# SERVICE BULLETIN No.1162

<b>COACH BUS MODEL</b>	: T2145
<b>BULLETIN TYPE</b>	: Field Change Program
<b>MANUAL SECTION</b>	: Electrical system
<b>DATE</b>	: May 23, 2005
<b>SUBJECT</b>	: <b>Headlamp identification marks</b>
<b>TERMS &amp; CONDITIONS</b>	: Refer to the Warranty Information in this Bulletin.

## Technical Bulletin - Research and Development -

Subject: Hella SSB 448  
Hella SSB 449

Figure 1: 1. Headlamp assembly (high beam) –  
2. Headlamp assembly (low beam)

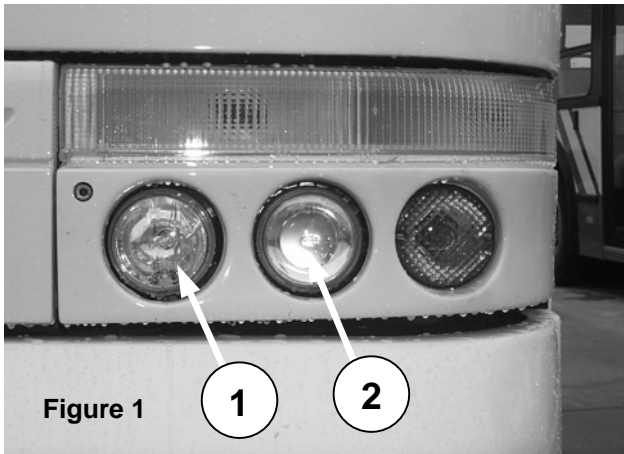
1. Hella, manufacturers of the headlamps currently installed on the above-mentioned coaches, have informed Van Hool that a non-compliance exists regarding the low and high beam identification marks (see Figures 1 and 2 overleaf).
2. To address the issue, Hella are conducting a field change program, which involves sticking labels on the headlamp lens to complete the existing marks in accordance with FMVSS108.
3. Owners and operators of the affected units should change the headlamp marks of their coaches without delay as per attached Hella Technical Bulletin "SSB 448 and SSB 449".

Figure 2: Missing headlamp mark
